TOWN OF BRISTOL, RHODE ISLAND

PLANNING BOARD MEETING

RE: **Ramos Landscaping -Minor Land Development – Preliminary Review
Special Use Permit**

Re: **Preliminary Submission Plan**
674 Metacom Avenue
Owner: Lionel J. Ramos
AP 128 Lot 15 & 16
Pare Project No. 98166.00, Task 109

Pond 8P: BIORETENTION

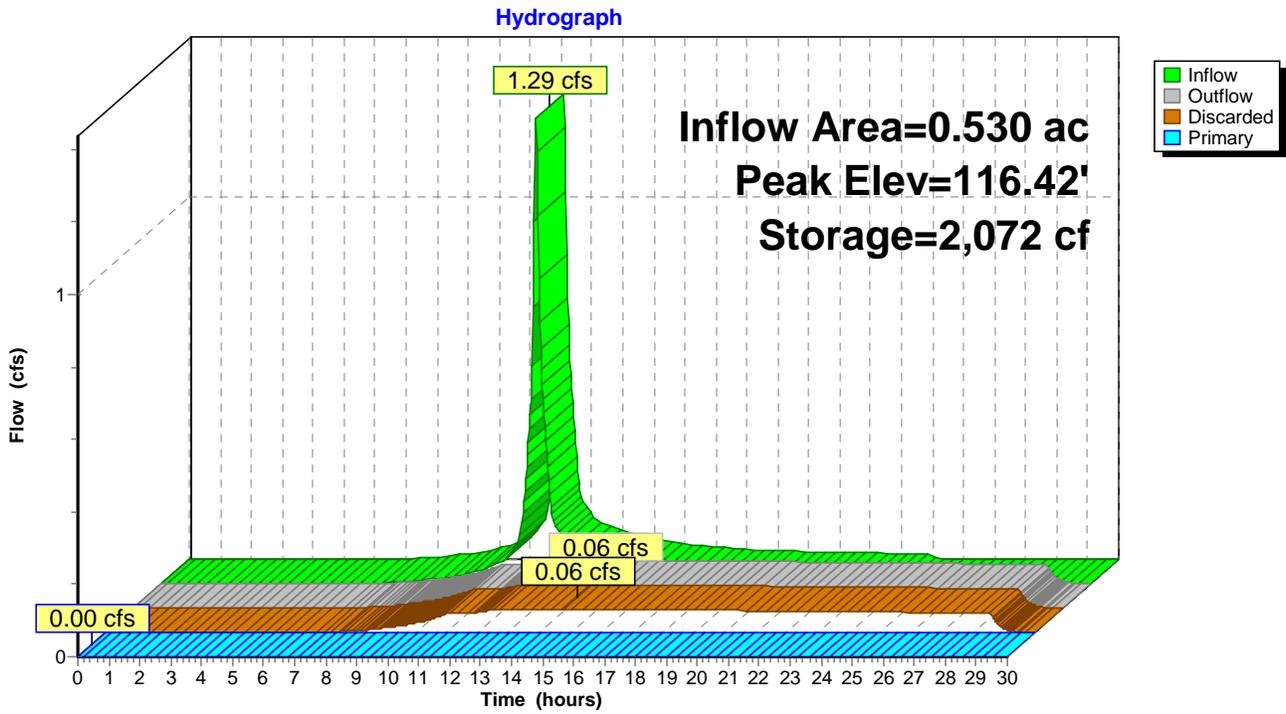
6. The proposed bioretention pond has a depth of only one foot and offers limited freeboard - approximately 3.5 inches during a 10-year storm event and 2 inches during a 100-year event. Due to the fact that the pond has a narrow berm and there is no flow diversion proposed, it is recommended that the pond be revised to provide additional freeboard.

RESPONSE: Freeboard depth is a preferred condition, not a requirement, and is usually a protective measure for downslope abutters, etc. In this instance, the downslope condition is a pond/wetland and therefore personal or property damage is not an issue. Further, trying to increase the depth of the system could result in increased side slopes, increased maintenance requirements and erosive flows. As this project has been submitted to RIDEM for their review, we have not revised the basin at this time.

SHEET **8** OF 14

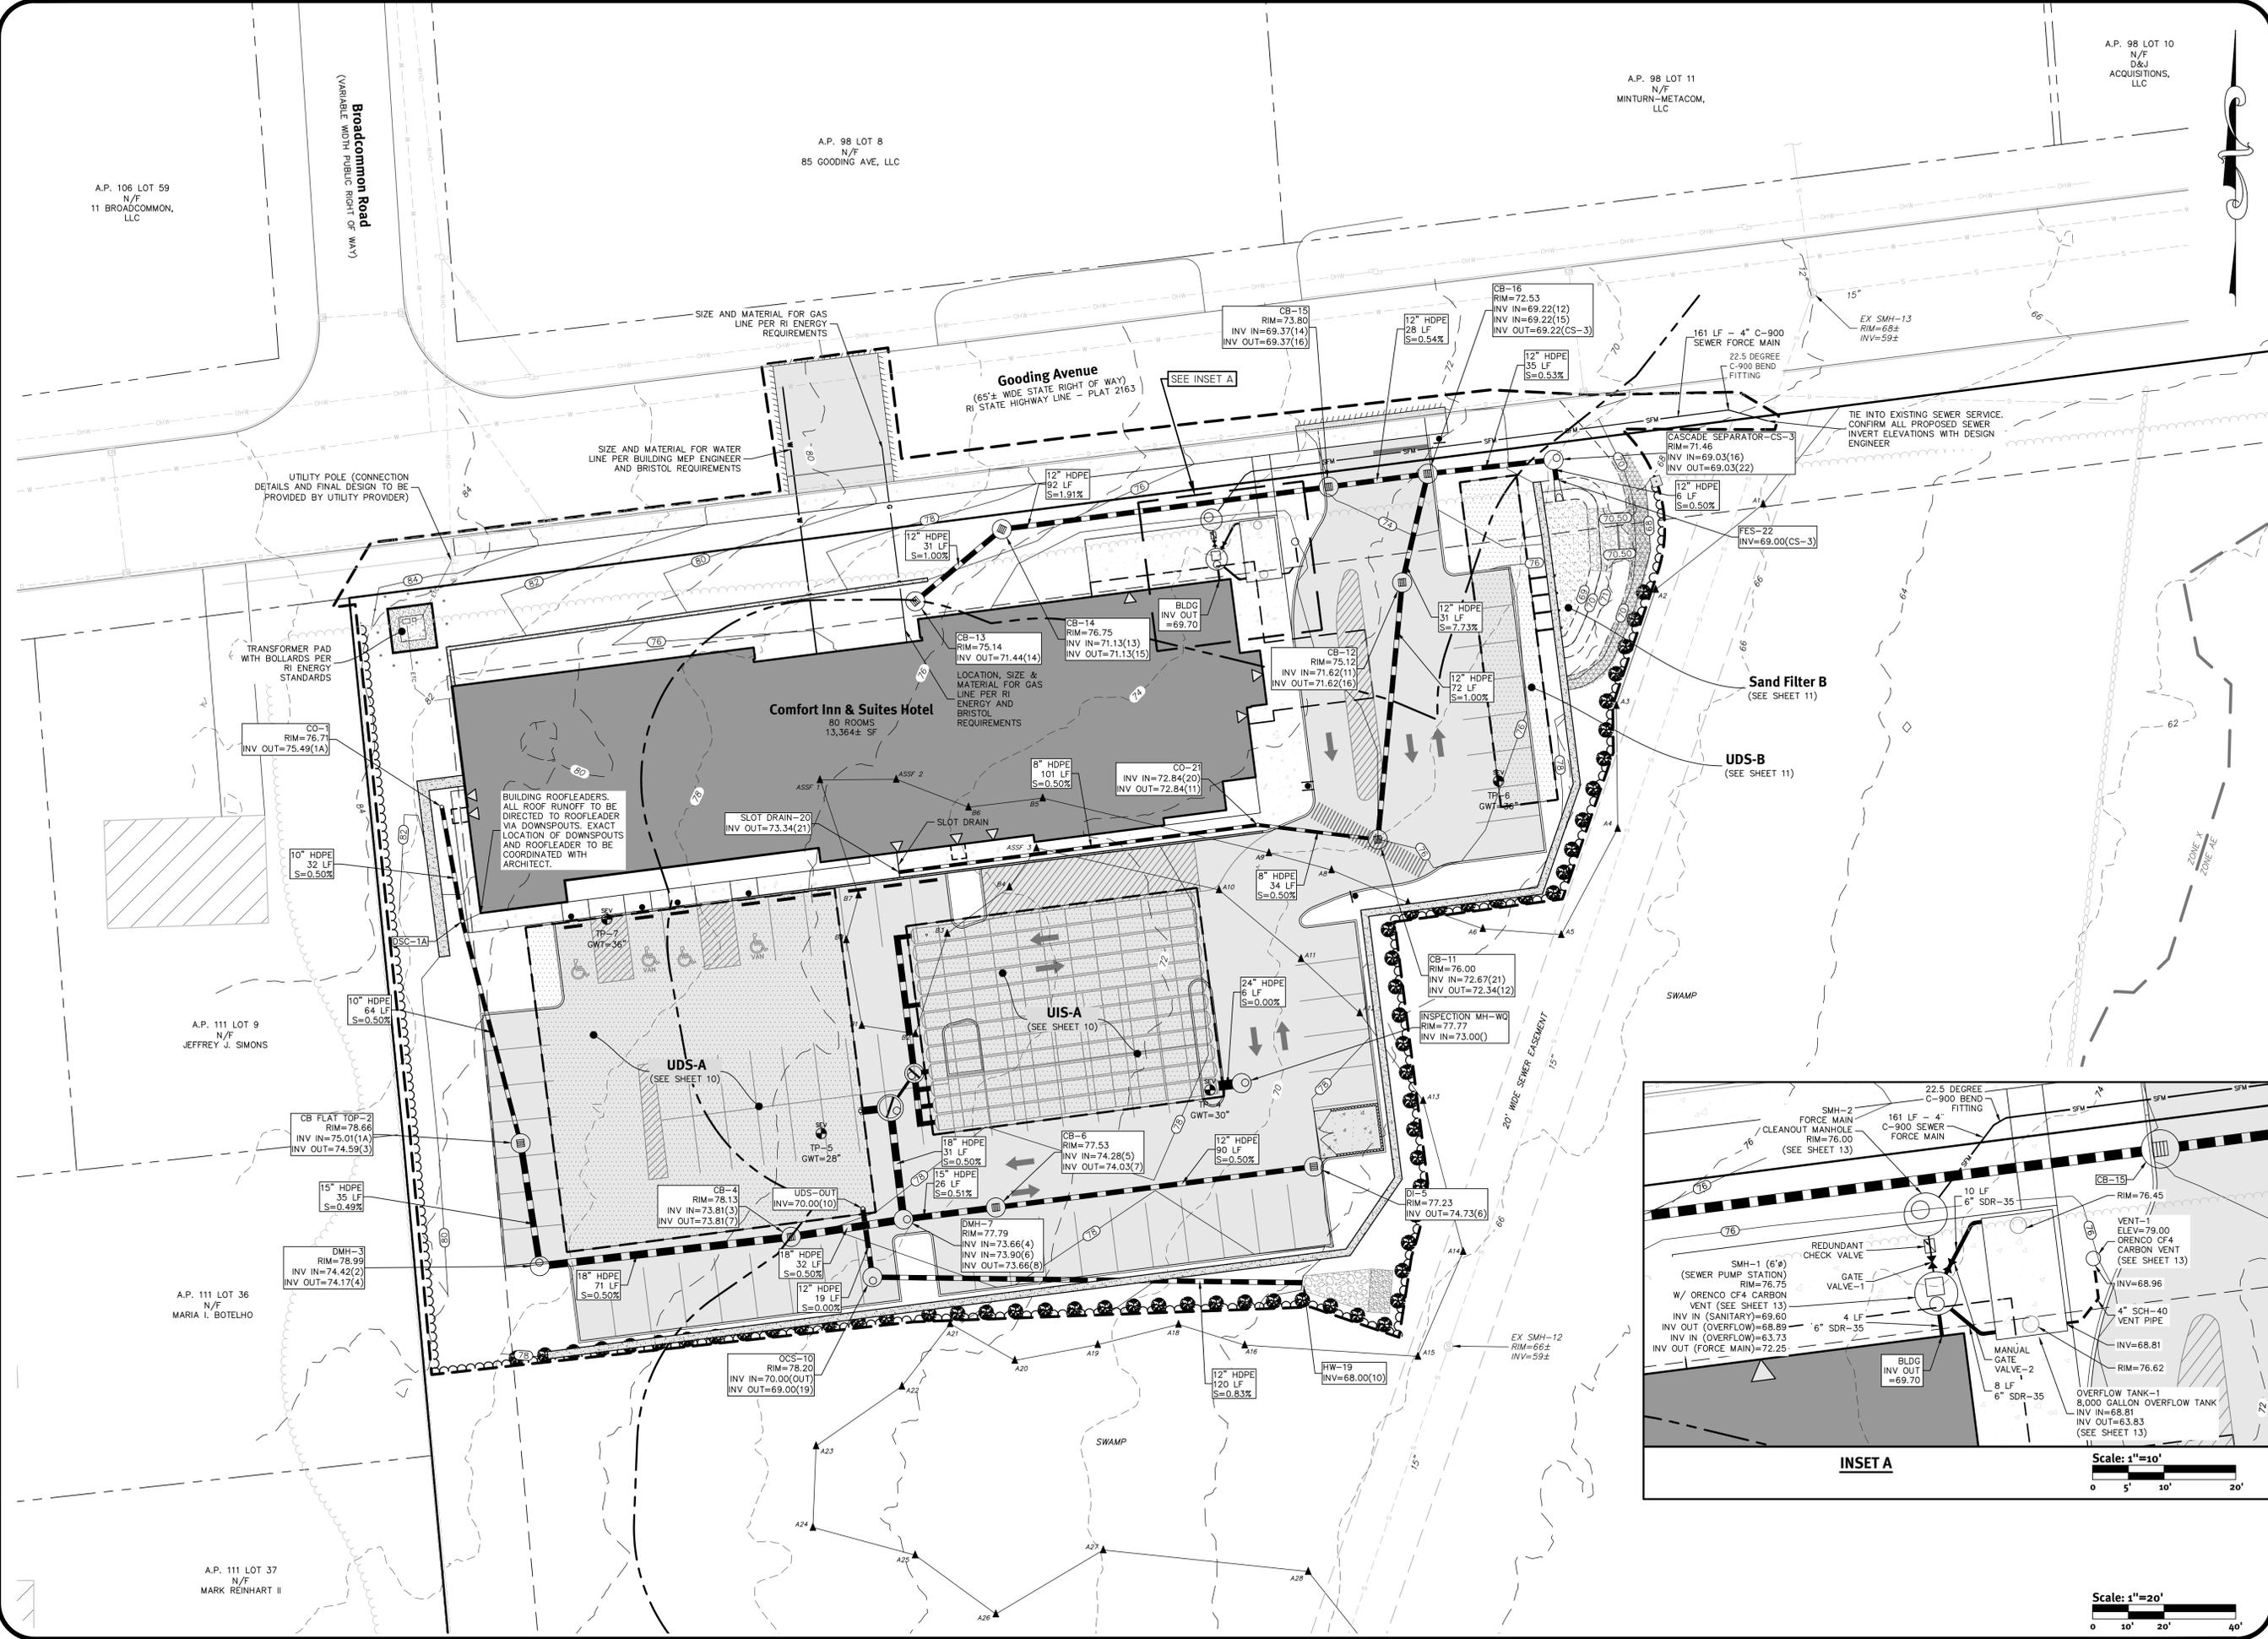
6. Drainage and Utilities Plan (Sheet 8 of 13)
- a. Provide rim and invert information for DMH-8 (Bypass) and DMH-9 (Bypass).
 - b. Provide rim elevation of Slot Drain-20.

STORMTECH SC-740 TYPICAL CROSS SECTION (SAND FILTER)

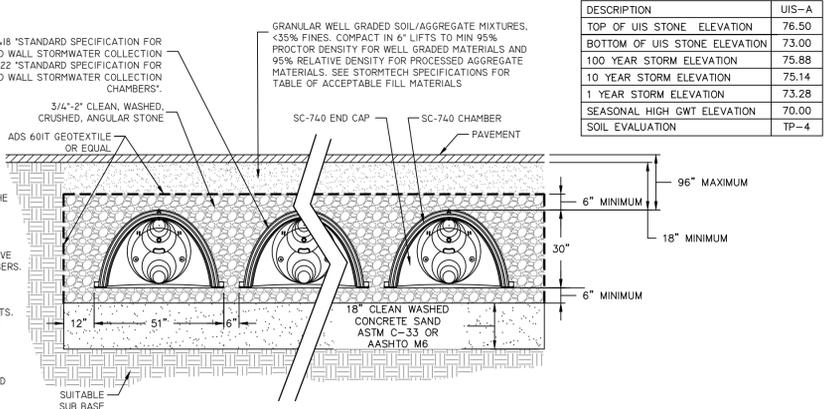
8. Underground System B, Sand Filter & Details (Sheet 11 of 13)
- a. Separation of bottom of sand filter practice and groundwater table is 1-ft and not in compliance with the minimum separation requirement of 3 feet per 250-RICR-150-10-8.21.B.7.
